RFI-3

Drawing Title
ELECTRICAL LIGHTING PLAN

Project Title
BUILDING 37 IS SUITE
DESIGN

Location
VA MED. CENTER, CANANDAIGUA,
NY

Drawing Number
EL-101

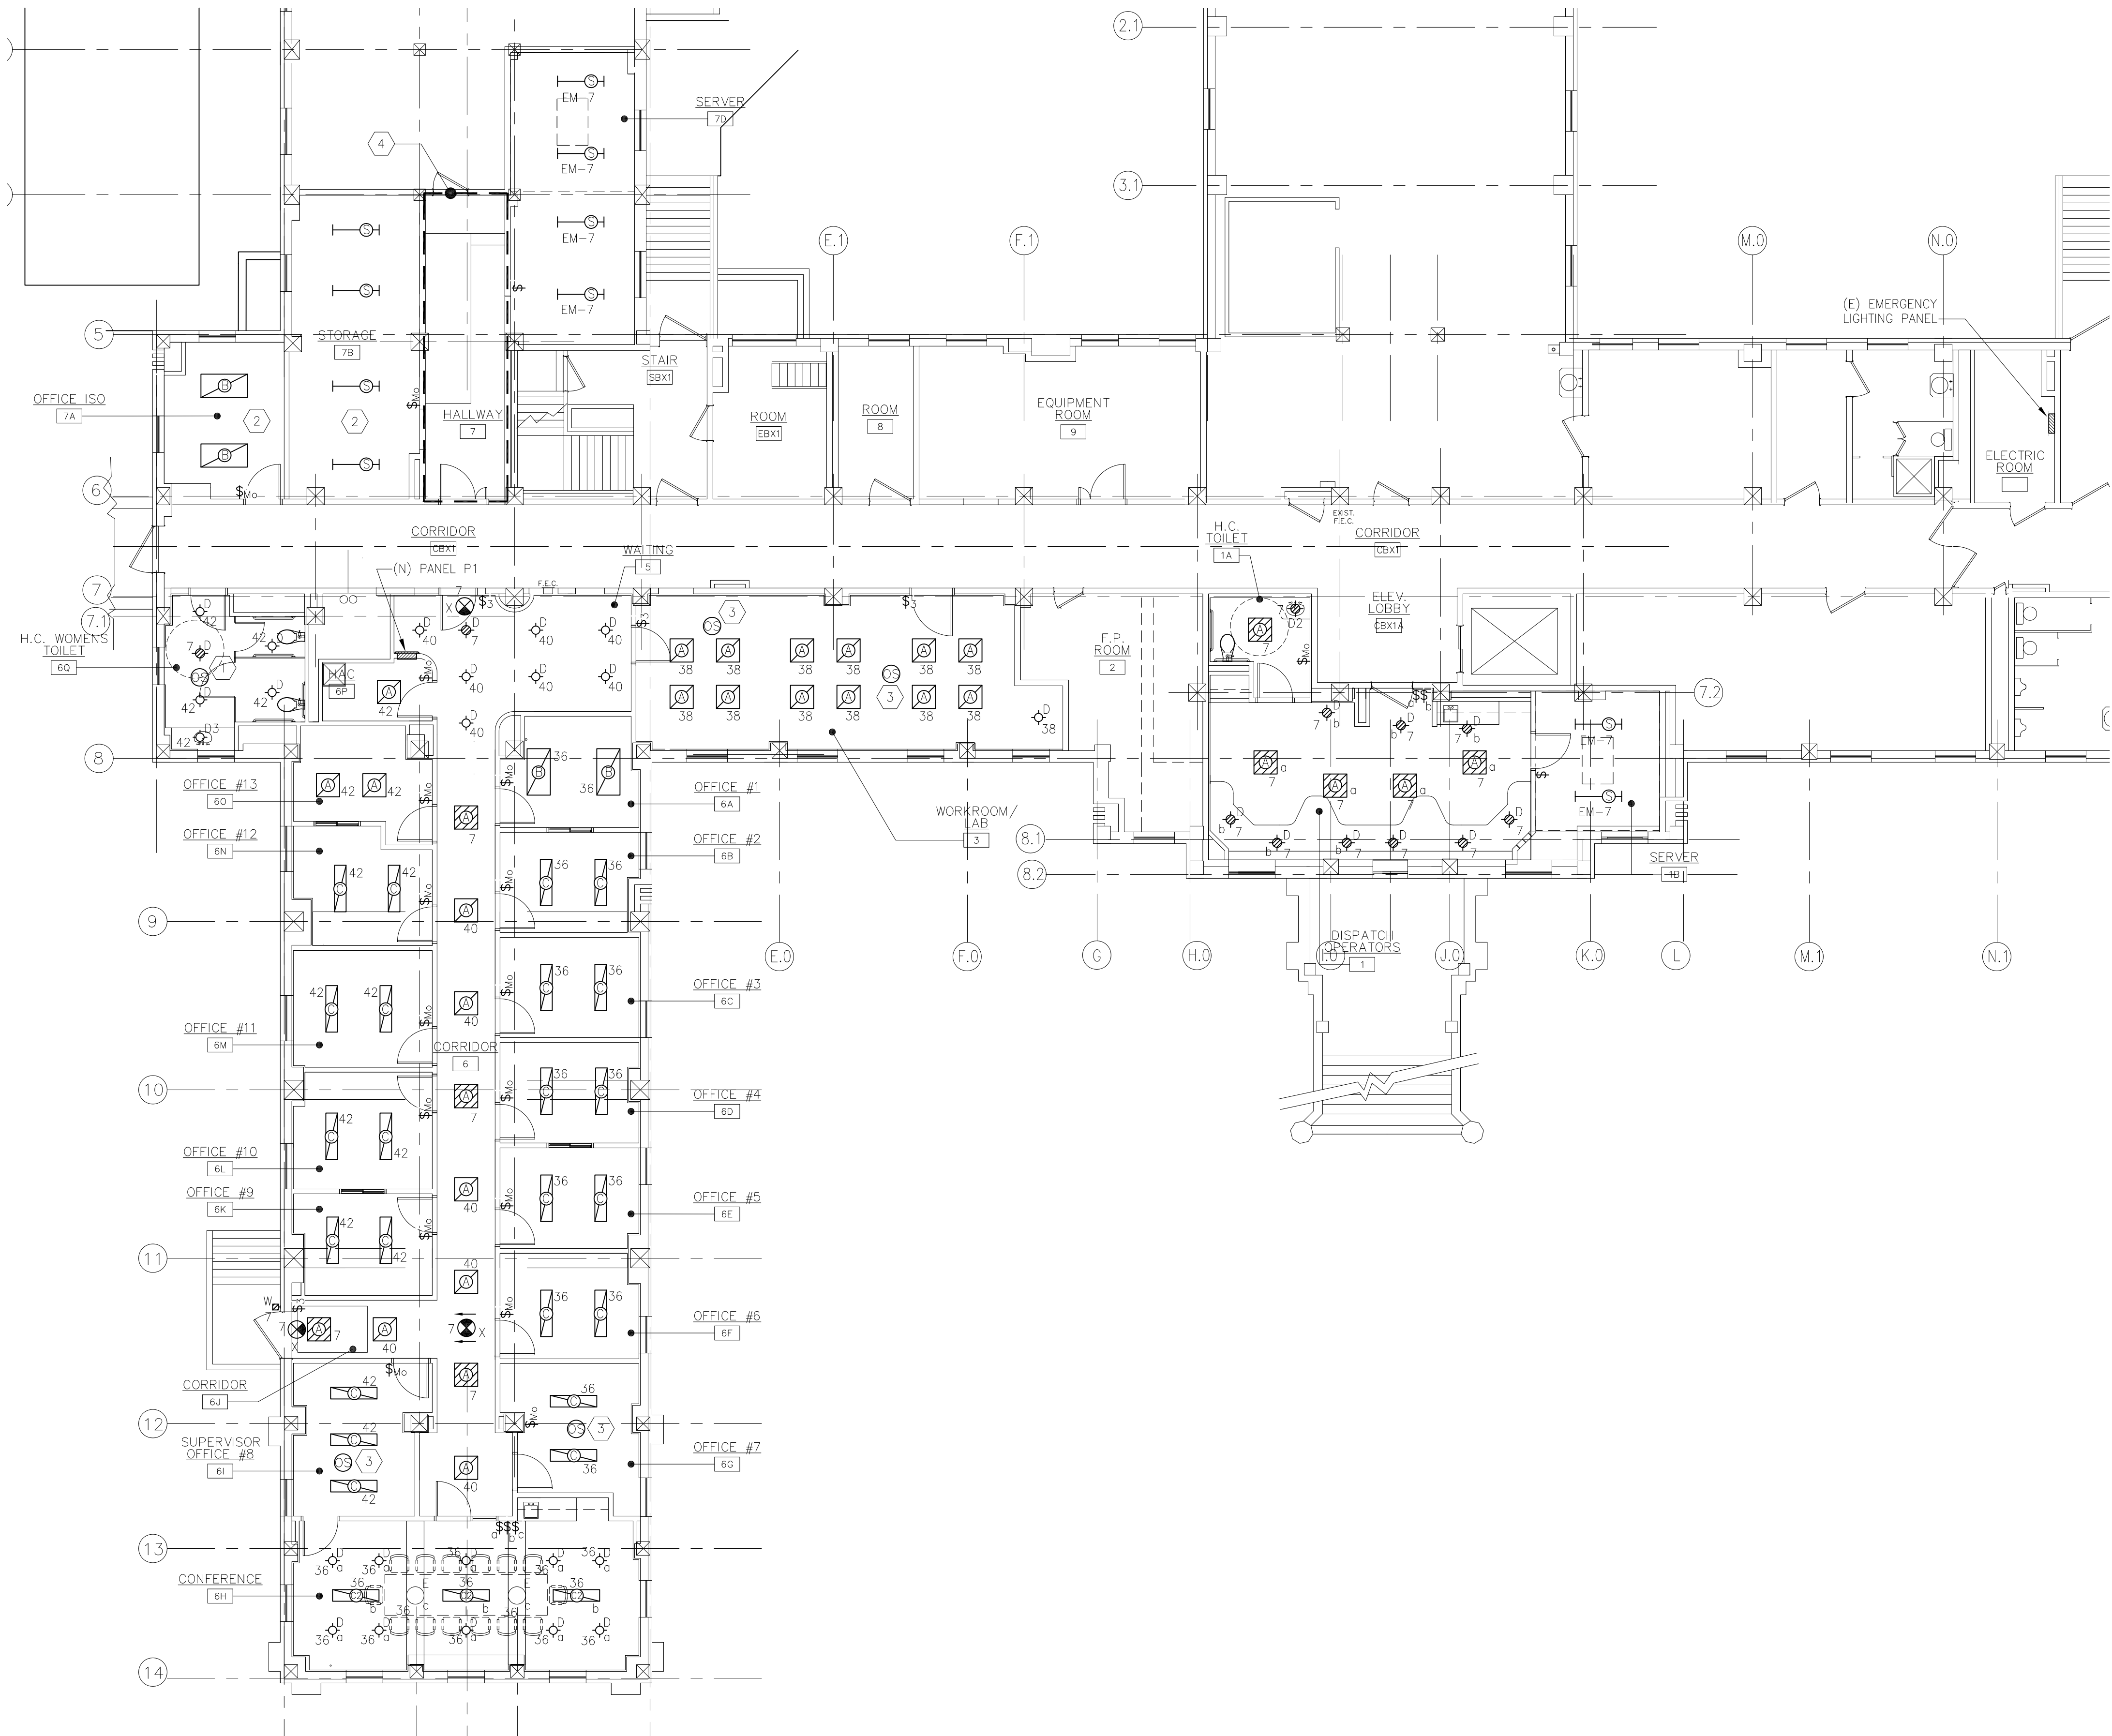
Fixture types C2, S, D3, D2, W and exits as shown on drawing EL-101 do not appear on the fixture schedule, please clarify.

Answer: Fixture schedule has been updated. See attached.
